THE SERVICED GRID CODE – ISSUE 6 REVISION 11

THE GRID CODE – ISSUE 6 REVISION 11

The changes arise from the implementation of modifications proposed in the GC0137 Final Modification Report:

GC0137: Minimum Specification Required for Provision of GB Grid Forming (GBGF) Capability (formerly Virtual Synchronous Machine/VSM Capability)

Figure ECC.6.3.19.5(a)

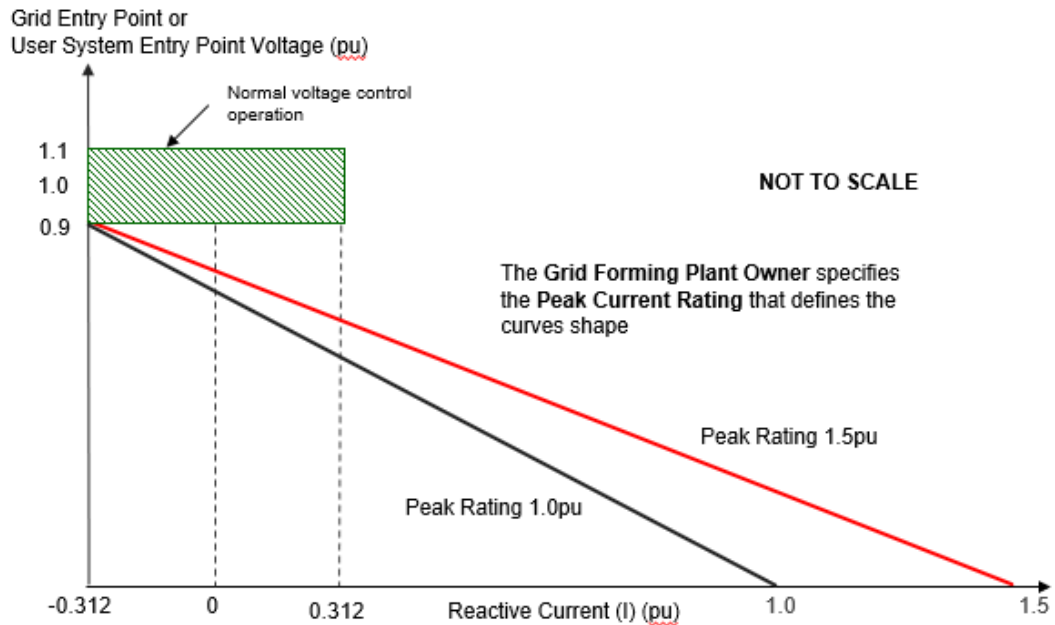
ECC.6.3.19.5.1 For any balanced fault which results in the positive phase sequence voltage falling below the voltage levels specified in CC.6.1.4 or ECC.6.1.4 (as applicable) at the **Grid Entry Point** or **User System Entry Point** (if **Embedded**), a **Grid Forming Plant** shall, as a minimum be required to inject a reactive current of at least their **Peak Current Rating** when the voltage at the **Grid Entry Point** or **User System Entry Point** drops to zero. For intermediate retained voltages at the **Grid Entry Point** or **User System Entry Point**, the injected reactive current shall be on or above a line drawn from the bottom left hand corner of the normal voltage control operating zone (shown in the rectangular green shaded area of Figure ECC.6.3.19.5(a)) and the specified **Peak Current Rating** at a voltage of zero at the **Grid Entry Point** or **User System Entry Point** as shown in Figure ECC.16.3.19.5(a). Typical examples of limit lines are shown in Figure ECC.16.3.19.5(a) for a **Peak Current Rating** of 1.0pu where the injected reactive current must be on or above the black line and a **Peak Current Rating** of 1.5pu where injected reactive current must be on or above the red line.

ECC.6.3.19.5.2 Figure ECC.6.3.19.5(a) defines the reactive current to be supplied under a faulted condition which shall be dependent upon the pre-fault operating condition and the retained voltage at the **Grid Entry Point** or **User System Entry Point** voltage. For the avoidance of doubt, each **Grid Forming Plant** (and any constituent element thereof), shall be required to inject a reactive current which shall be not less than its pre-fault reactive current and which shall as a minimum, increase each time the voltage at the **Grid Entry Point** or **User System Entry Point** (if **Embedded**) falls below 0.9pu whilst ensuring the overall rating of the **Grid Forming Plant** (or constituent element thereof) shall not be exceeded.

Figure ECC.6.3.19.5(b)

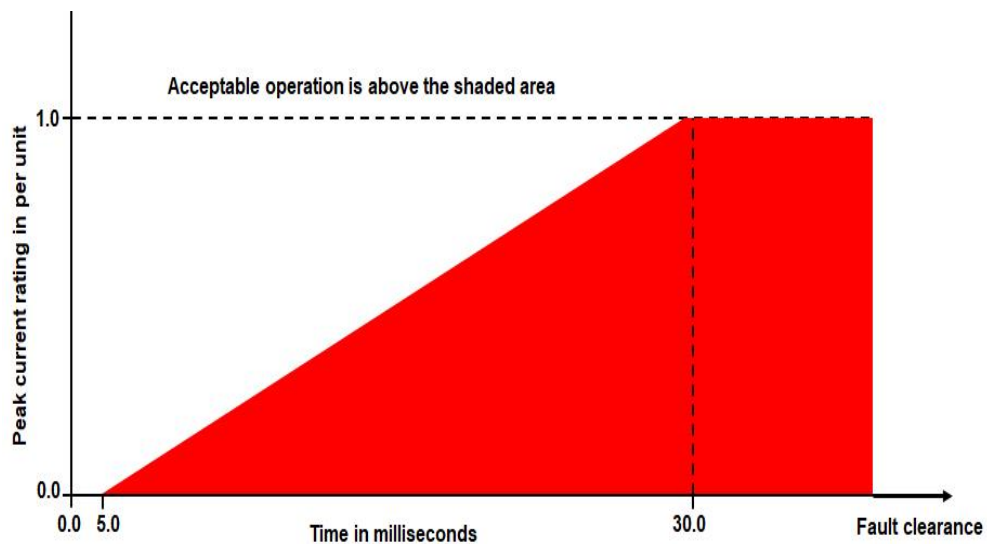
ECC.6.3.19.5.3 In addition to the requirements of ECC.6.3.19.5.1 and ECC.6.3.19.5.2, each **Grid Forming Plant** shall be required to inject reactive current above the shaded area shown in Figure ECC.6.3.19.5(b) when the retained voltage at the **Grid Entry Point** or **User System Entry Point** falls to 0pu. Where the retained voltage at the **Grid Entry Point** or **User System Entry Point** is below 0.9pu but above 0pu (for example when significant active current is drawn by loads and/or resistive components arising from both local and remote faults or disturbances from other **Plant** and **Apparatus** connected to the **Total System**) the injected reactive current component shall be in accordance with Figure ECC.6.3.19.5(a).

- ECC.6.3.19.5.4 The injected current shall be above the shaded area shown in Figure ECC.6.3.19.5(b) for the duration of the fault clearance time which for faults on the **Transmission System** cleared in **Main Protection** operating times shall be up to 140ms. Under any faulted condition, where the voltage falls outside the limits specified in CC.6.1.4 or ECC.6.1.4 (as applicable), there will be no requirement for each **Grid Forming Plant** or constituent part to exceed its transient or steady state rating as defined in Table PC.A.5.8.2.
